Comments on Final Draft 2009 Reserve Requirements Study: Peak Load Value Used in IRM and FPR Calculations

James F. Wilson
LECG LLC

PJM Planning Committee Meeting
October 22, 2009

Alternative Definitions of Median Summer Peak??

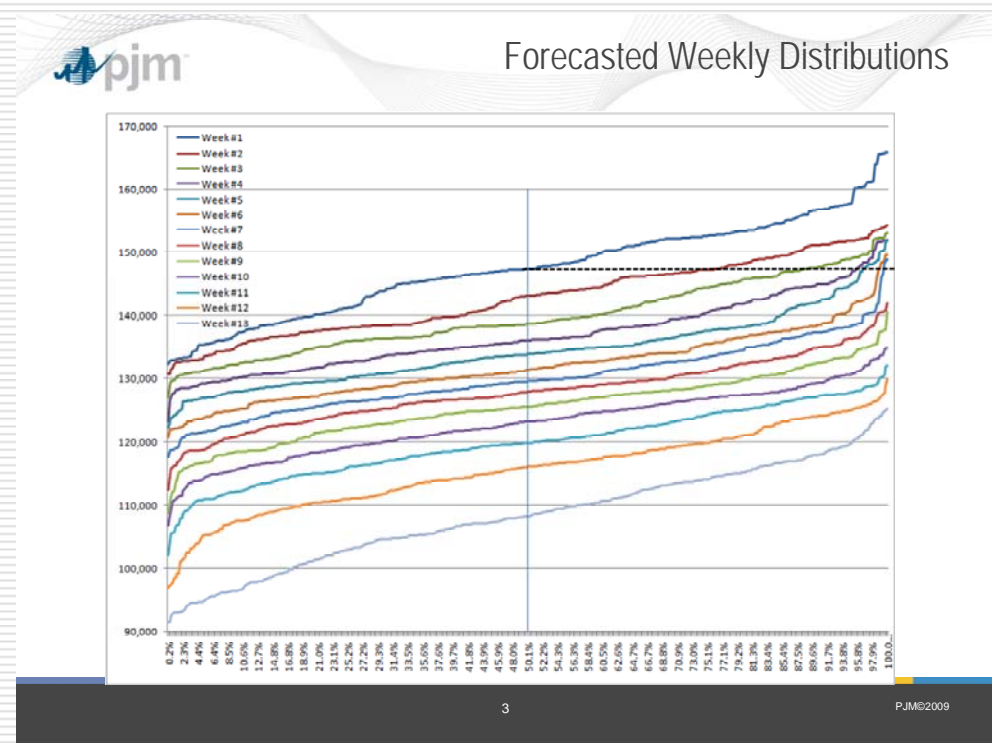
“The debate over the correct peak load to use in the denominator when stating the IRM calculated in PRISM is essentially a debate over the definition of a “50/50” summer peak load. The IRM is applied to the “50/50” peak day load that is produced by the PJM load forecast model so it is critical that the PRISM “50/50” peak load be consistent with the load forecast model “50/50” peak day load.”

There is only one definition of a median summer peak load. It is that load value believed to have a 50% chance of being greater than, 50% chance of being less than, the actual peak over the course of the summer.

PRISM Model's "Week 10" Does Not Represent the Distribution of Annual Peak

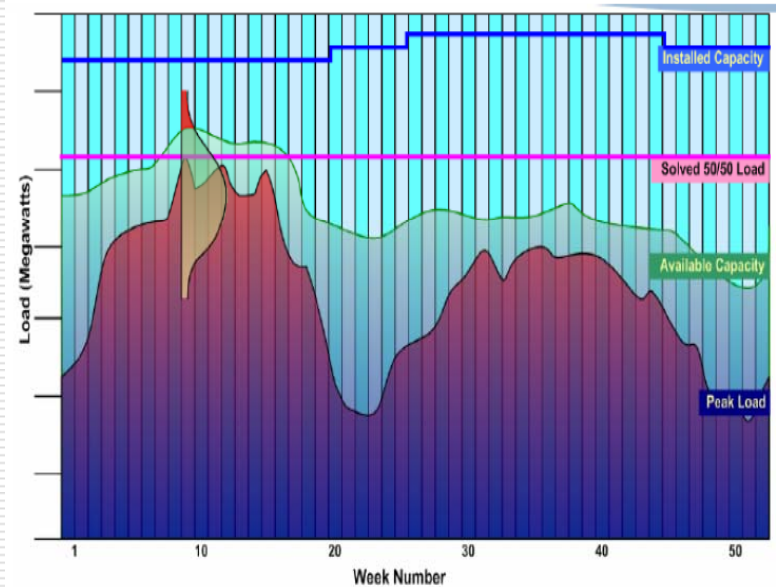
By contrast, PRISM models 52 weeks as probabilistically independent with mean and standard deviation. Week 10, confusingly referred to as the "peak" week, has the highest mean and is the *most likely* to have the highest value (the annual peak), but in the model, 37% of the time another week has a higher value.

If PRISM were changed such that week 10's peak must be the annual Peak and other weeks' peaks must be lower (as in the load forecast distribution), it's a different load model, and produces a lower IRM.
